ADDENDUM NO: 03

DATE: 08 April 2025

PROJECT NO: 119.002

PROJECT: Hyde Park Elementary School
333 East 300 North
Hyde Park, Utah 84318

1 A902 LEVEL 02 TILT UP CONCRETE PANELS
1" = 10'-0"

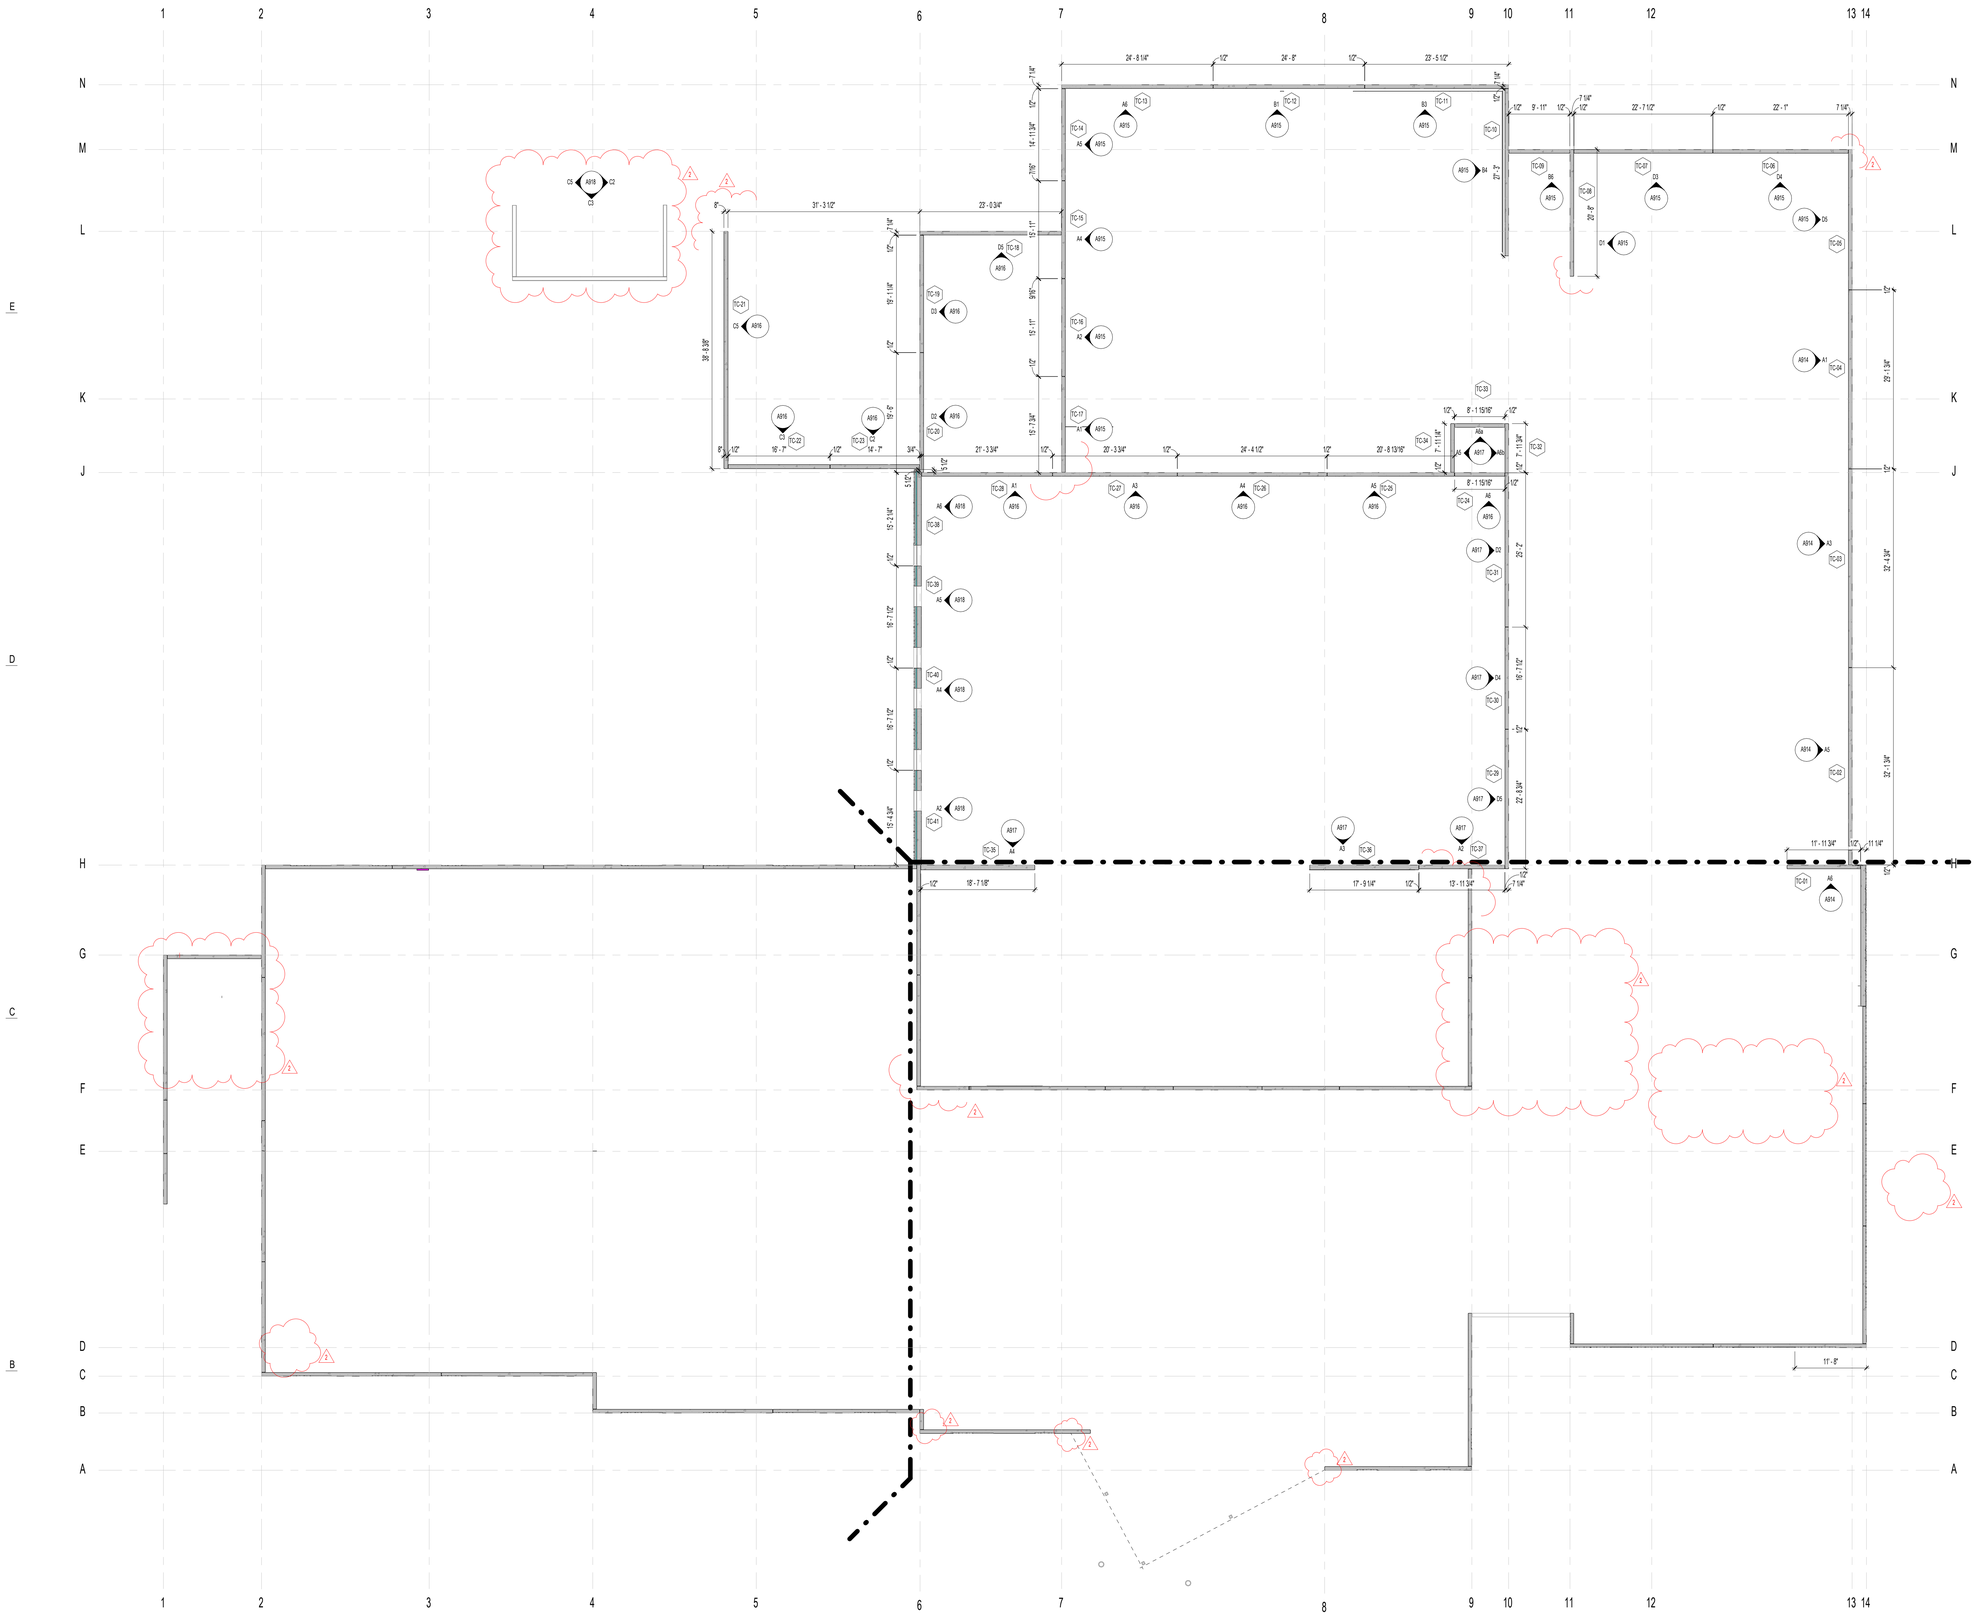
- **Section detail B6/ A920 removed from view.**
- **Stairs, mechanical equipment, and non-tilt panel lines/ walls were removed from view to provide better clarity on plan.**
- **Placed trash enclosure wall elevations on view.**
- **Detail A1/ A918 call out removed from sheet**

CU301

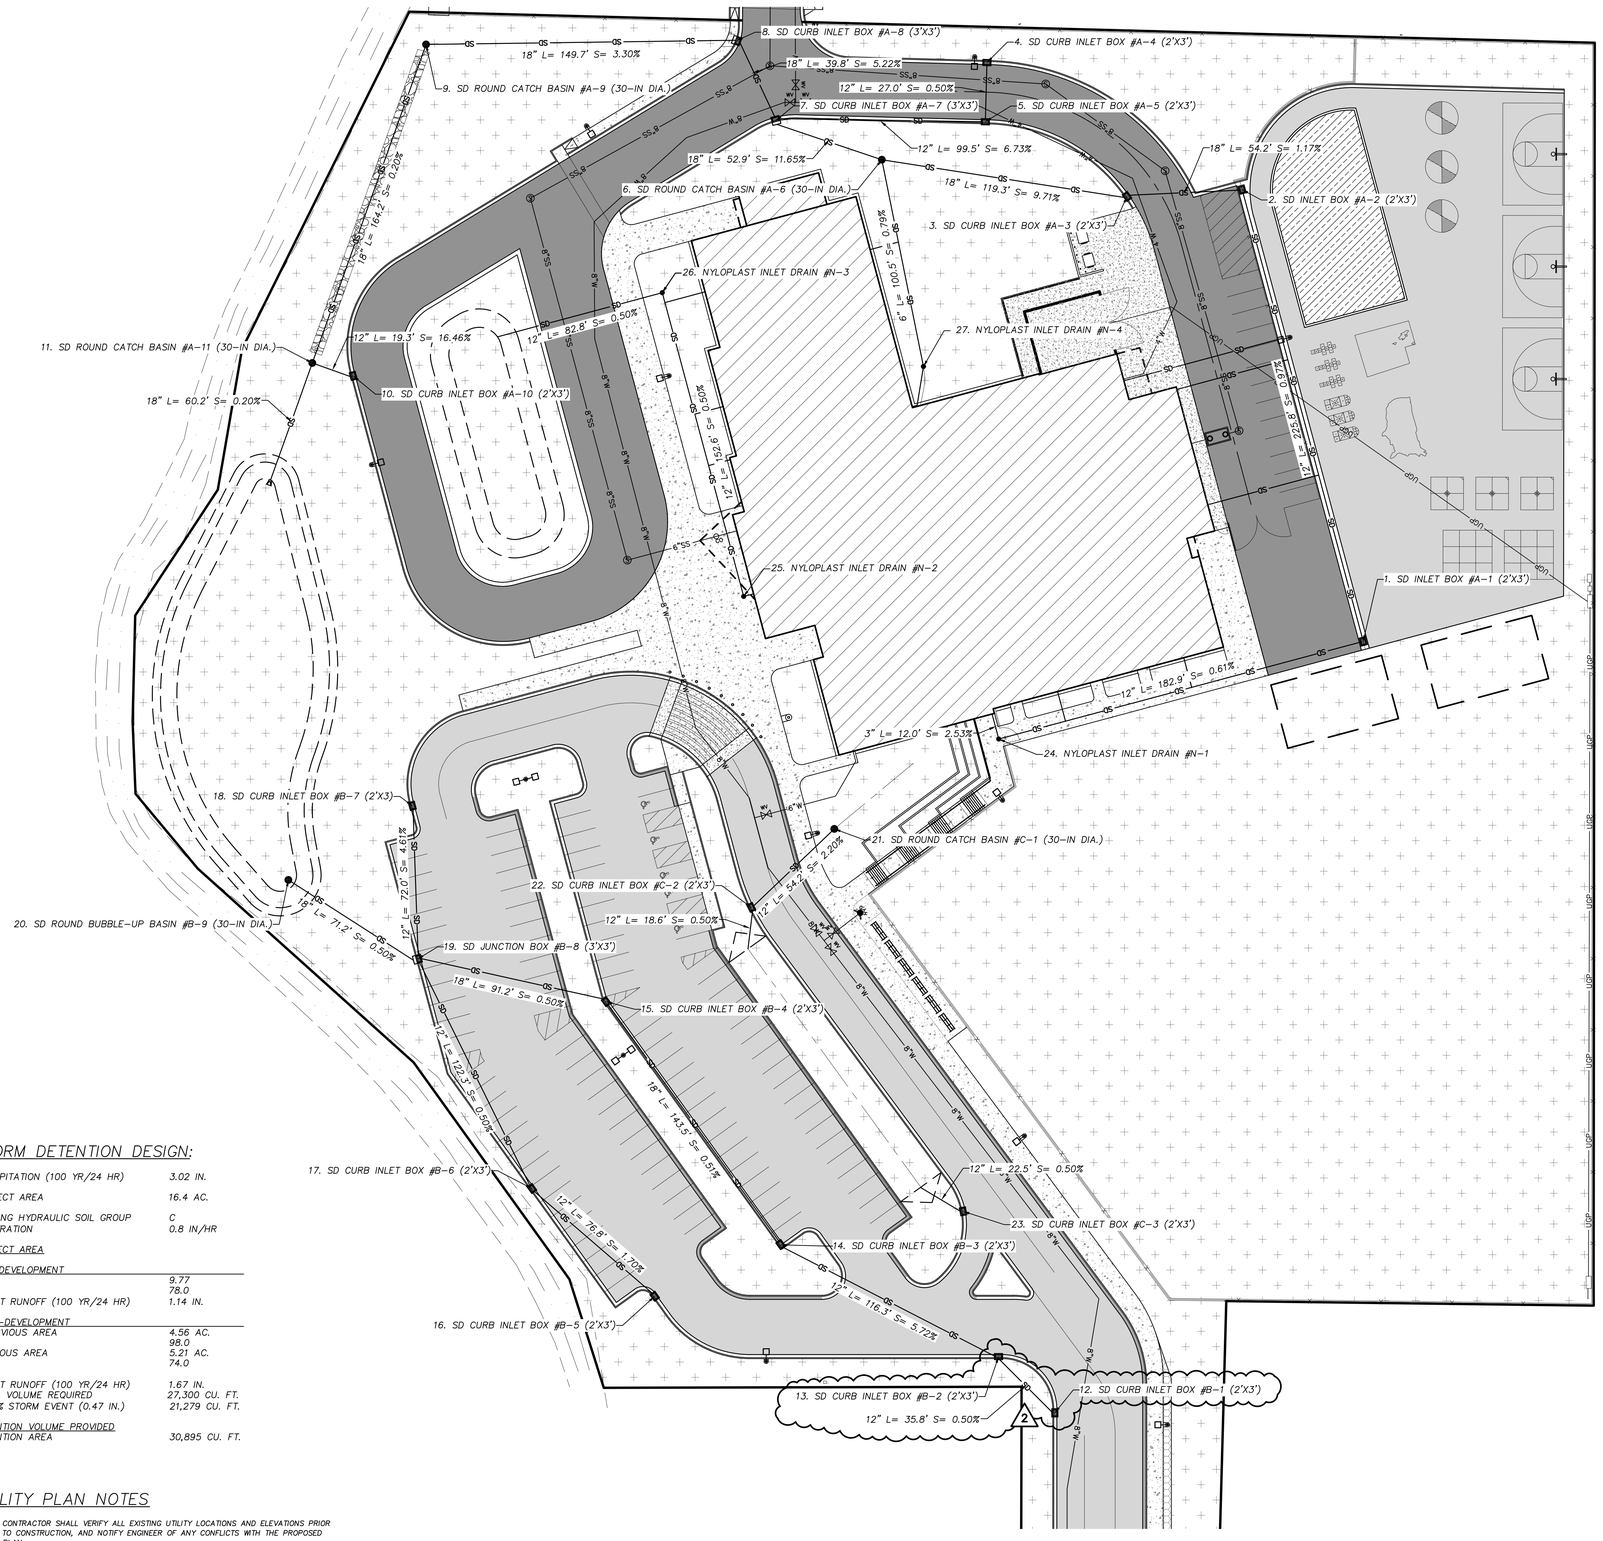
11. On sheet CU301, it is somewhat unclear where the storm drain pipe should be perforated pipe with fabric and rock. Please clarify the extent of the perforated pipe areas.

CU302

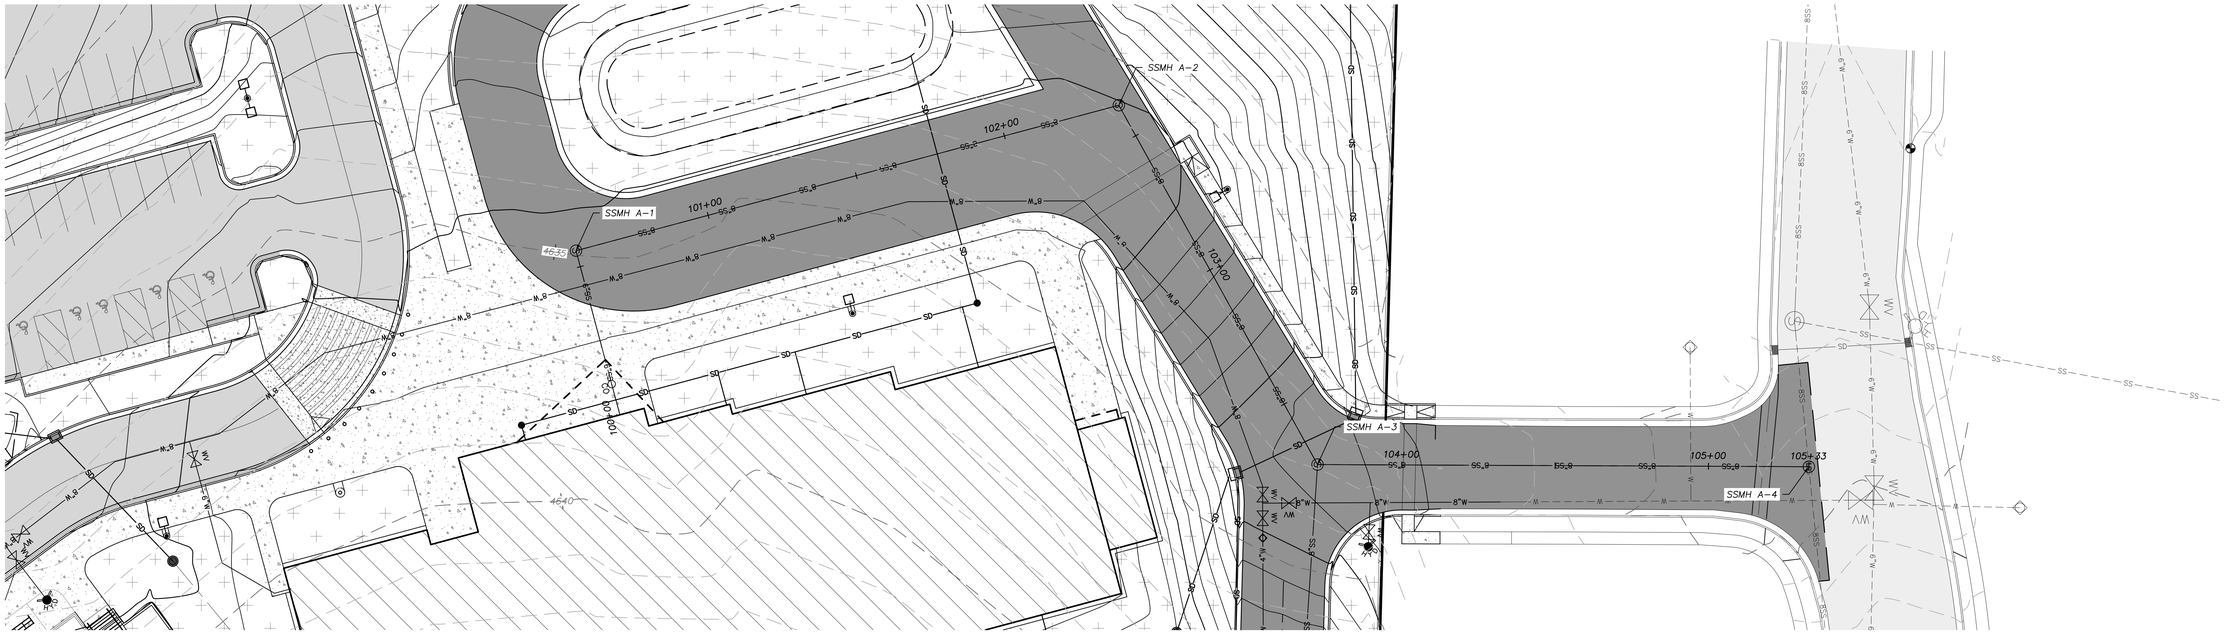
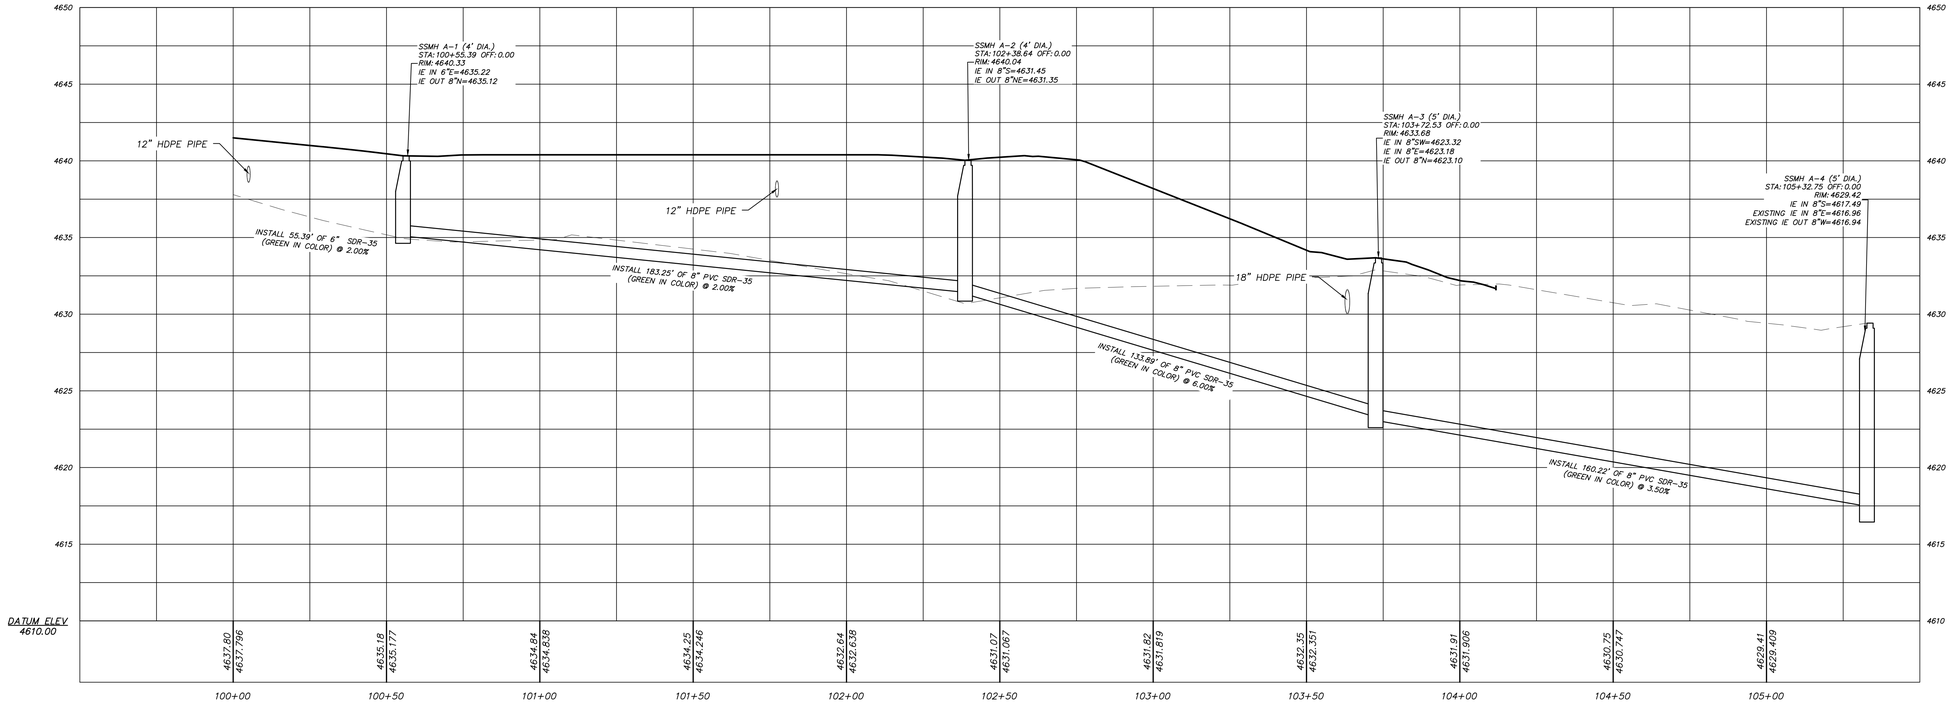
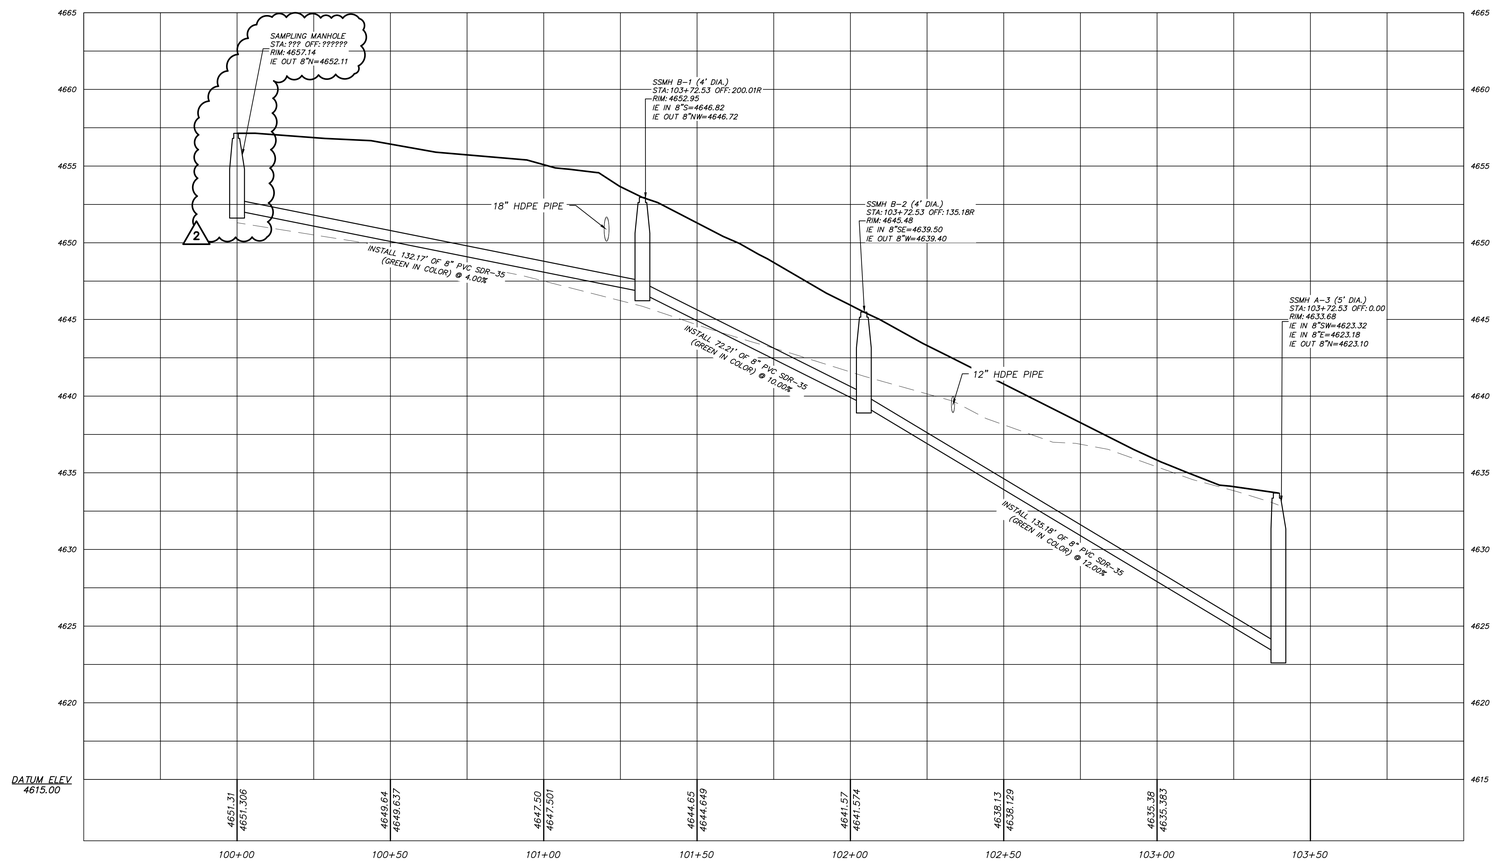
20. Referring to sheet CU302, there is a section of SD pipe in the landscape area between boxes C3 and C2 that is not called out. Please clarify. (See Attached) There is a similar line shown between the southwest building corner and the long set of stairs to the south between boxes C1 and N1.

RESPONSE FROM CACHELANDMARK: The manhole has been added to the plans. See sheet CU304.
